INSTRUCTION TO SERVICE

ITS: 5088

SECTION:	219 Engine and Transmission
WRITTEN BY:	Mike Pearson
SUBJECT:	Replace existing 24 volt SCR valve with correct 12 volt valve

Figure 1: SCR Coolant Valve Location

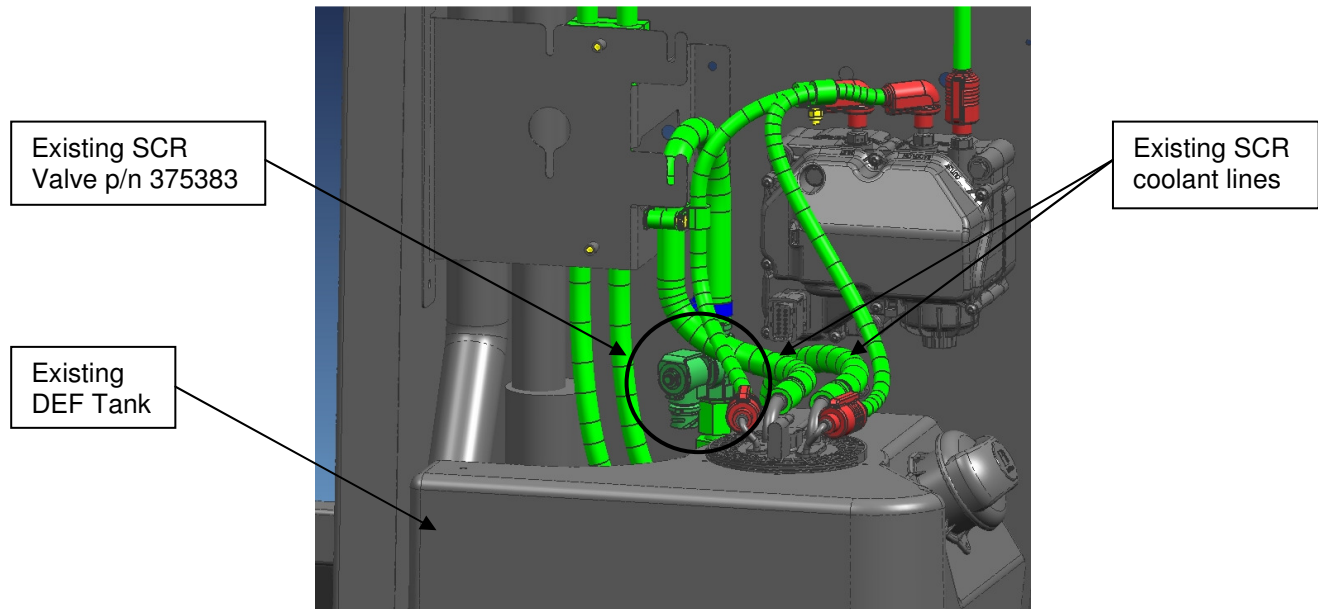
1. Turn the main battery disconnect switch to the "OFF" position.
2. Open the curbside corner pillar door and locate the SCR coolant valve. See Figure 1.

Figure 1: SCR Coolant Valve

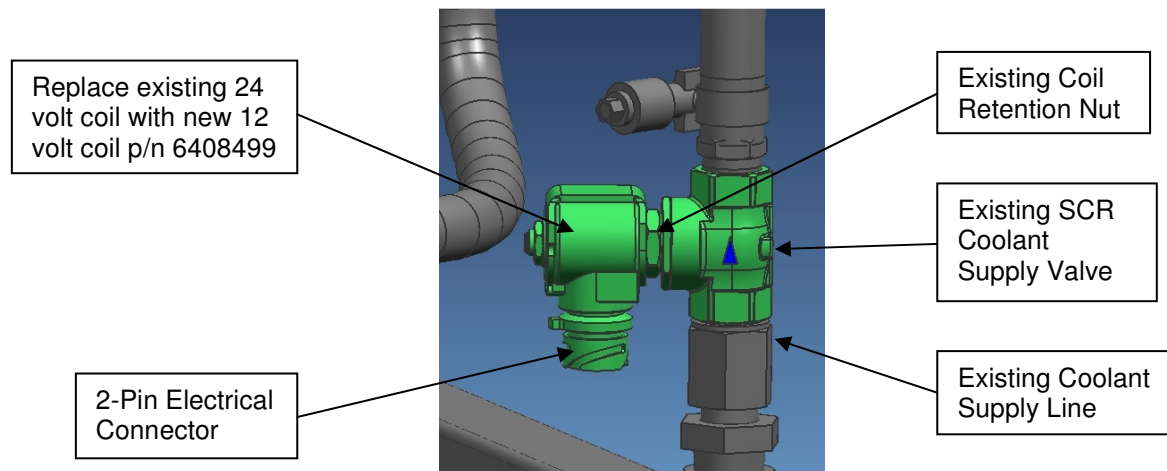
3. Disconnect the 2-pin electrical connector from the coil and set aside. See Figure 2.
4. Using a backup wrench remove the 24 volt coil from the existing SCR valve and replace it with new 12 volt coil p/n 6408499. Torque coil retention nut to 40-60 in*lbs using backup wrench.. Coil orientation to remain the same. See Figure 2.
5. Re-connect the 2-pin electrical connector removed in Step 3.
